# Submission Evaluation Report

Central Waste Facility Organics Processing Facility EIS

Prepared for Bega Valley Shire Council

18 September 2025

Figure 4-1: OPF and CWF Cumulative Independent Odour Dispersion Modelling Results (15,000 tpa Scenario)

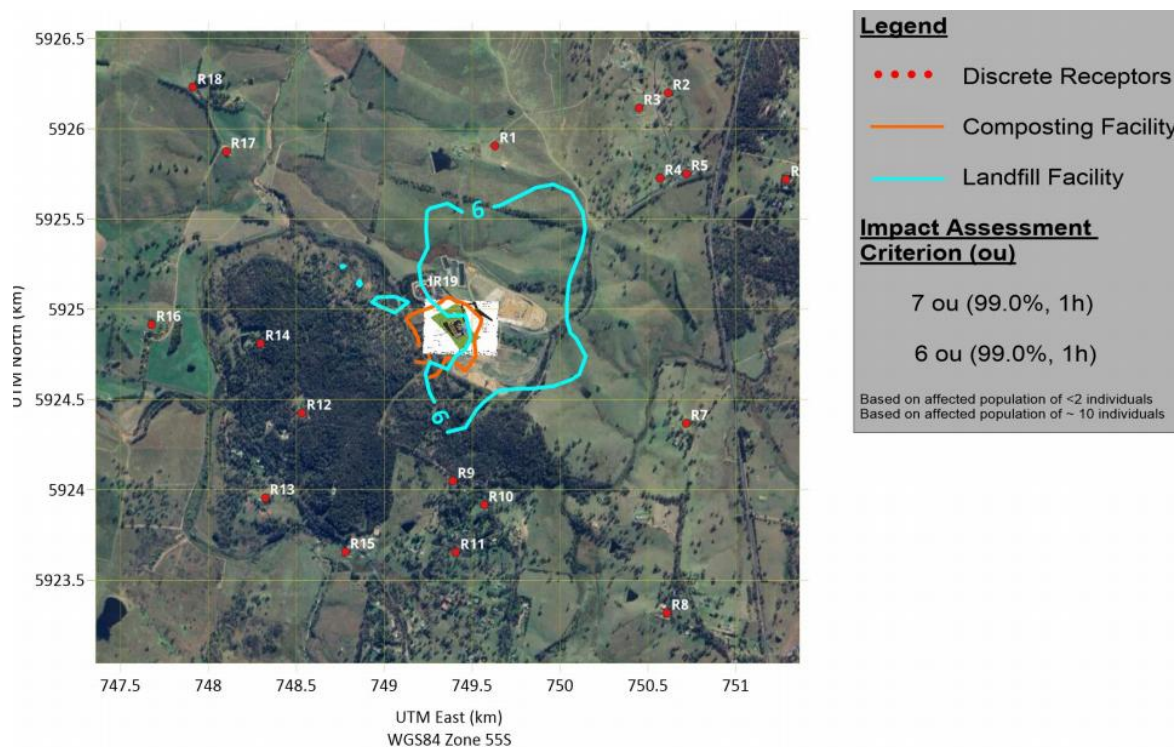
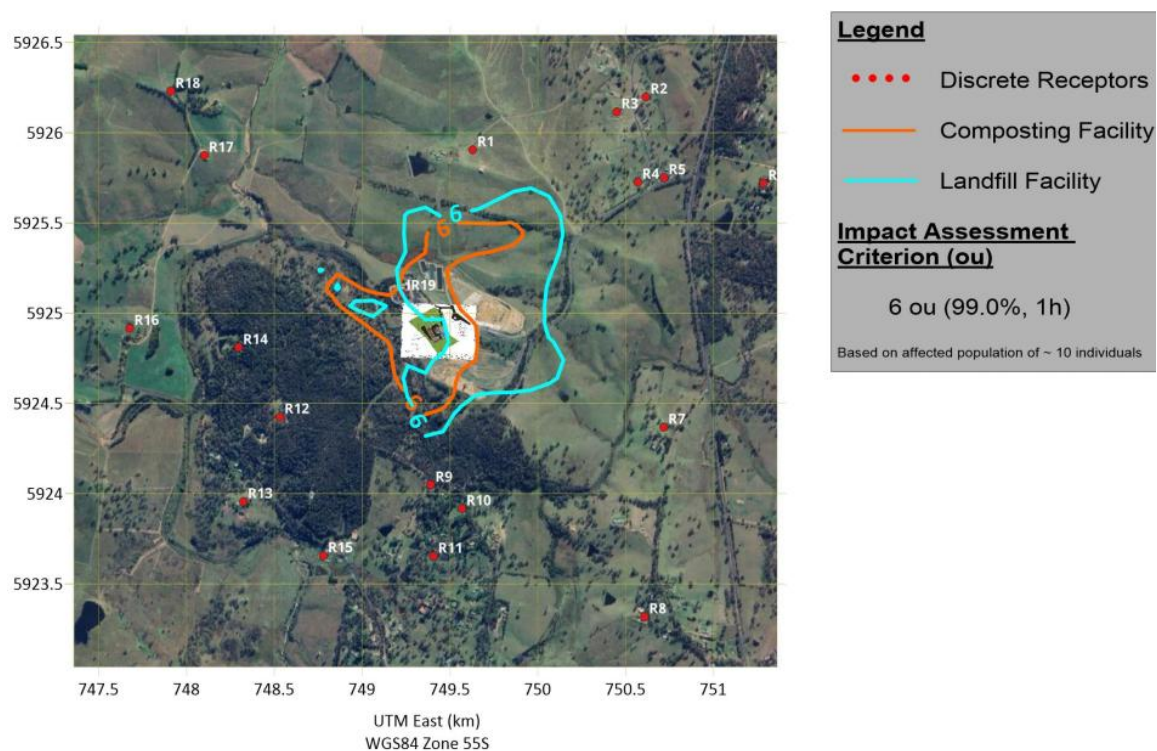
### **1. A revised odour assessment that includes a cumulative odour assessment that accounts for both the proposed composting and landfill activities.**

As outlined below in Figure 4-1 and Figure 4-2, the cumulative impacts were assessed using a combined model run that included both the composting facility and the Central Waste Facility, with each treated as an individual source group. When considered as two distinct sources, the cumulative impact effects for both odour profiles meet the relevant NSW EPA odour criterion. The air quality assessment conducted by The Odour Unit (TOU) concluded that all receptors subject to odour being emitted from the OPF and the landfill are predicted to be below the relevant NSW EPA Odour criterion during both the 15,000 tpa and 30,000 tpa stage. As a result, it is suggested that both existing and future impacts can be managed to an extent that does not adversely impact the local amenity at the nearest sensitive receptor under normal operations.

The AQOIA did assess cumulative impacts from the composting and landfill activities, but these were modelled as distinct odour source types within a single cumulative scenario. This is consistent with Section 3.3 of the NSW EPA Technical F & N, which *recommends* distinguishing sources with distinct odour characteristics. The composting process (CASP using FOGO) and landfill (putrescible waste) differ in both odorant composition and emission dynamics. As shown in Figure 5.7 and Figure 5.8 of the AQOIA, the cumulative impacts were assessed using a combined model run that included both the composting facility and the Central Waste Facility, with each treated as an individual source group. This approach also aligns with Barclay & Scire (2011), which recommends defining separate source groups to enable attribution of contributions and allow targeted mitigation. The use of distinct source profiles allowed us to more accurately represent the real-world dispersion of odours from each facility and avoids inappropriate lumping of emissions that could mischaracterise their combined effects.

Figure 4-3: OPF Odour Dispersion Modelling Results (15,000 tpa Scenario)

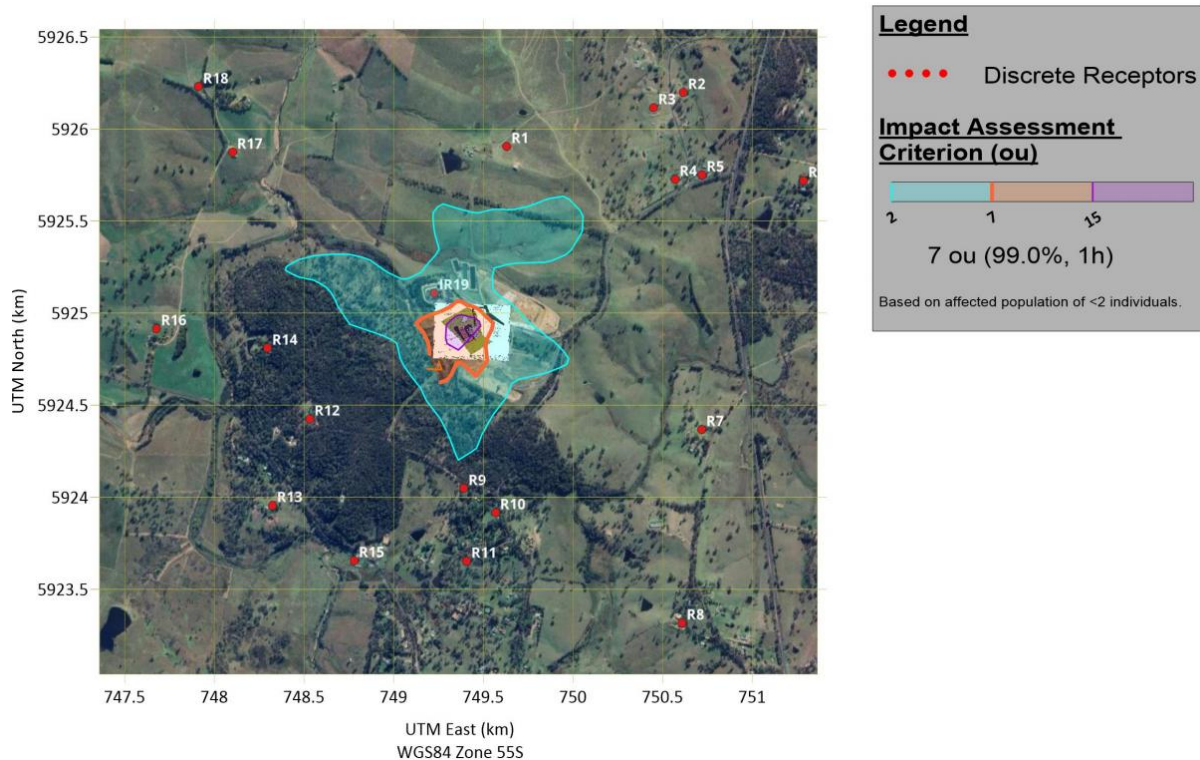
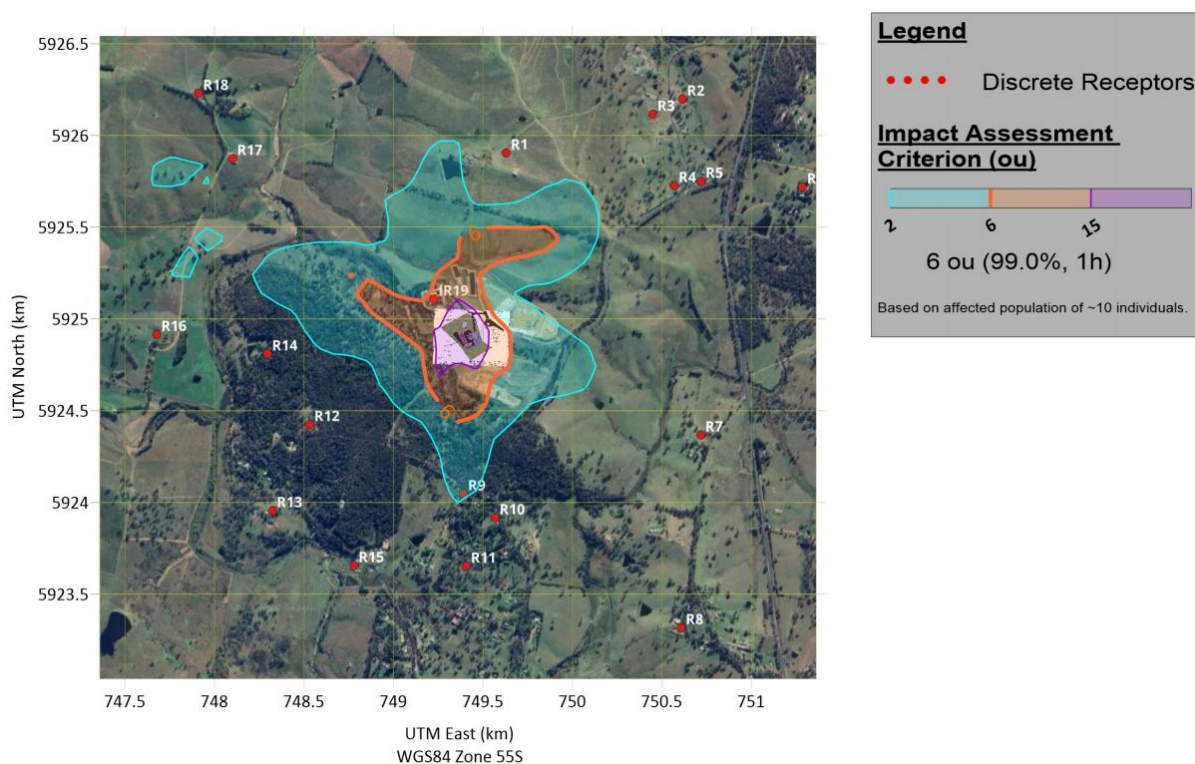
### **3. The odour assessment must be revised to demonstrate compliance with the odour impact assessment criteria.**

Odour dispersion modelling results for the OPF at its initial capacity of 15,000 tpa (Phase 1) and extended capacity of 30,000 tpa (phase 2) have been provided below in **Figure 4-3** and **Figure 4-4** against the IAC determined by the technical framework. As seen within **Figure 4-3** and **Figure 4-4**, the impact area associated with the odour during both phases does not exceed the respective 7 ou and 6 ou (99.0%, 1-hr) criteria at the nearest discrete sensitive receptors.

Industrial receptor 19 in the below **Figure 4-3** and **Figure 4-4** is representative of the NBN Co satellite ground station that is adjacent to the existing CWF and development. It is understood that IR19 will have a single full-time staff member on-site and can be remotely monitored. Therefore, the modelled peak emissions at IR19 under the existing CWF and OPF development conditions (including 30,000 tpa) are not considered problematic based on the modelled frequency and duration of occurrence when the NSW EPA criterion of 6 ou is exceeded.

Of note, in **Figure 4-4**, isolated pockets of odour developing separately from the main odour plume centred around the development and in closer proximity to additional receptors are found to exist. These isolated pockets are a result of the topographical and meteorological conditions (most notably during the early morning) occurring at the CWF and do not exceed the 6 ou (99.0%, 1-hr) criteria associated with the 30,000 tpa scenario.

The NSW EPA Approved Methods provide odour impact criteria for sensitive receptors, which include residences, schools, and hospitals, but not industrial or commercial facilities. The NBN site has been confirmed to have no regular public access, and site operations are attended by a single full-time staff member during daytime hours only. As such, the reported exceedance at IR\_19 represents a technical exceedance only and does not indicate a material off-site impact at a location defined as a sensitive receptor under the NSW EPA Technical F & N. Furthermore, this exceedance occurs under isolated composting conditions, and the cumulative scenario - which includes both composting and landfill sources - shows that all receptors, including IR\_19, remain below the adopted 6 ou criterion. No residential or community receptors exceed the impact assessment criteria under any modelled scenario, including cumulative impacts. Therefore, the Proposed Works is demonstrated to be compliant with odour assessment requirements.
